Evaluation of a proposal for reliable low-cost grid power with 100% wind, water, and solar.

Proceedings of the National Academy of Sciences of the United States of America, 114(26)

Evaluation of a proposal for reliable low-cost grid power with 100% wind, water, and solar

Fig. 1. This figure (figure 4B from ref. 11) shows hydropower supply rates peaking at nearly 1,300 GW, despite the fact that the proposal calls for less than 150 GW hydropower capacity. This discrepancy indicates a major error in their analysis. Modified from ref. 11.

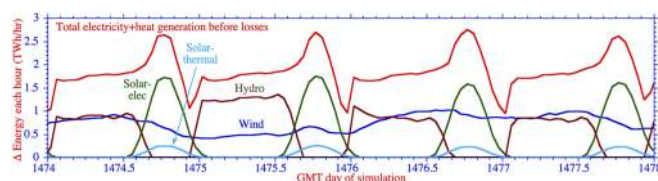
As we detail in *SI Appendix*, section S1, ref. 11 includes several modeling mistakes that call into question the conclusions of the study. For example, the numbers given in the supporting information of ref. 11 imply that maximum output from hydroelectric facilities cannot exceed 145.26 GW (*SI Appendix*, section S1.1), about 50% more than exists in the United States today (15), but figure 4B of ref. 11 (Fig. 1) shows hydroelectric output exceeding 1,300 GW. Similarly, as detailed in *SI Appendix*, section S1.2, the total amount of load labeled as flexible in the figures of ref. 11 is much greater than the amount of flexible load represented in their supporting tabular data. In fact, the flexible load used by LOADMATCH is more than double the maximum possible value from table 1 of ref. 11. The maximum possible from table 1 of ref. 11 is given as 1,064.16 GW, whereas figure 3 of ref. 11 shows that flexible load (in green) used up to 1,944 GW (on day 912.6). Indeed, in all of the figures in ref. 11 that show flexible load, the restrictions enumerated in table 1 of ref. 11 are not satisfied.

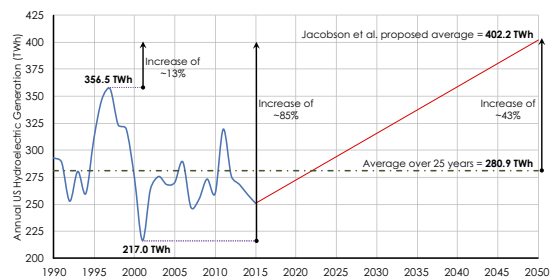
To illustrate the implausibility of the assumed increase in hydroelectric net generation (dispatched from the plants to the electricity grid) in the face of limited water supply, we plot in Fig. 3 the last 25 y of generation from hydropower in the United States along with the average for the studies in refs. 11 and 12. The data used for Fig. 3 can be found in *Datasets S1* and *S2*. Average future generation assumed by refs. 11 and 12 is 13% higher than the highest peak year in the last 25 y and 85% higher than the minimum year in the last 25 y. Therefore, in addition to needing 1,300 GW of peak power from 150 GW of capacity, there also needs to be an extra 120 TWh of hydroelectric gener-

Figure 3 of the present paper shows that the 100% wind, solar and hydroelectric power system in ref. [11] consumes 43% more annual hydroelectric energy than in recent history. This extra energy will be needed at different times, in addition to current activities at hydroelectric power plants. Presumably, the changes needed to be made would cause water levels to rise and fall quite dramatically throughout the year. The additional water needed for the increased energy is not accounted for in either [11] or [12]. The authors of ref. [11, 12] state that the reservoir sizes do not increase, but this cannot be the case because more power is being drawn and therefore the head level will decrease rapidly, lowering power output.

Fig. S1. Panel B of Figure 4 of ref. [11]

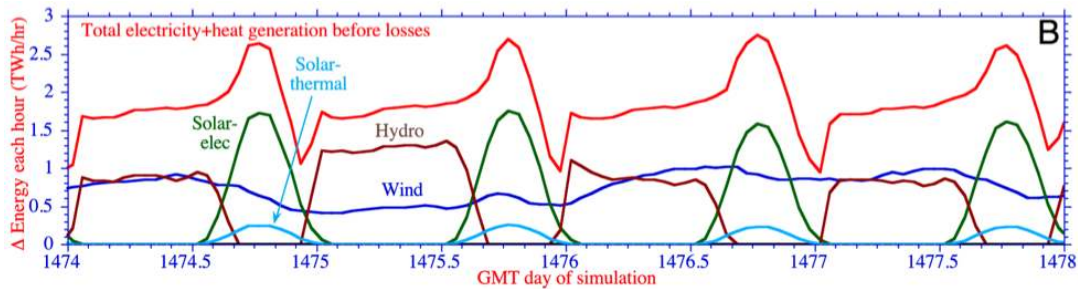
S1.1: Hydroelectric Capacity. The analysis in ref. [11] relies on much more hydroelectric capacity than can reasonably be expected to be available. In ref. [11], the total installed hydroelectric power capacity in the U.S. system, as defined in Table S2 of its supporting information (SI), is 87.48 GW. In addition to this, Table S1 of its SI defines the maximum discharge rate for new pumped hydroelectric capacity (assuming that all of this is completely new capacity and not existing capacity with added pumping) to be 57.68 GW¹. Thus, assuming that conventional hydroelectric generation and “pumped” hydroelectric power production capacity is separate, the total maximum theoretical output of all hydroelectric capacity postulated in ref. [11] is 145.16 GW.

Figure S1 (which corresponds to Panel B of Figure 4 in ref. [11]), shows the power supplied by different sources in TWh/hr, which is effectively the average power for each hour in the unit of TW, for a period of four days in January of 2055. Readers of ref. [11] are given only a few snapshots of the modeling results, but as an example, for half of the simulated day of 15th of January 2055, hydropower is depicted as supplying ~84% of total system load, averaging 1.3 TW (1,300 GW) over a period of 13 hours, or approximately 9 times the theoretical maximum instantaneous output of all installed conventional hydropower and pumped storage combined. It is not feasible for an installed hydropower capacity of 87.48 to 145.16 GW (depending on whether pumped hydro is included in these figures in the hydro output or in non-underground thermal energy storage output) to produce 1,300 GW for hours at a time. It is worth noting that 1,300 GW is more than the current combined generating capacity of all the U.S. power plants. Furthermore, this error is not limited to a single figure in ref. [11]. The hydroelectric production profiles depicted throughout the dispatch figures reported in both the paper and its supplemental information routinely show hydroelectric output far exceeding the maximum installed capacity as well. Both Figures S4 and S5 of its SI, for example, depict hydroelectric generation rates exceeding 700 GW. This error is so substantial that we hope there is another explanation for the large amounts of hydropower output depicted in these figures. In [12] the authors state that “We constrain hydropower to existing capacity in each state except in the case of Alaska.” Then in [11] the authors state values from [12] are used.

Fig. S3. Lowermost panel of Figure S6 of ref. [11]

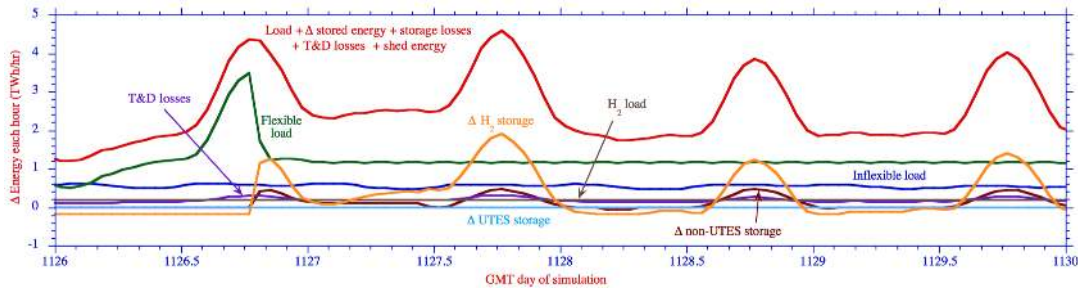
In addition, it appears from the modeling results shown in ref. [11] that no physical limitations have been placed on the rate of hydrogen production in the system. In Figure S6 of its SI, it is shown that a hydrogen charge rate (power going to hydrogen production) of almost 2 TW is achieved, nearly double the total current installed generating capacity of the United States. The actual capacity for hydrogen production is never explicitly presented in ref. [11] and is not appropriately accounted for in the cost estimates⁶. The authors of ref. [11] provide no information regarding the hydrogen production equipment (electrolysis, etc.) that would enable a hydrogen production rate of at least 2 TW, as shown in the dispatch figures (see the lowermost panel of their Figure S6; shown here below in Figure S3).
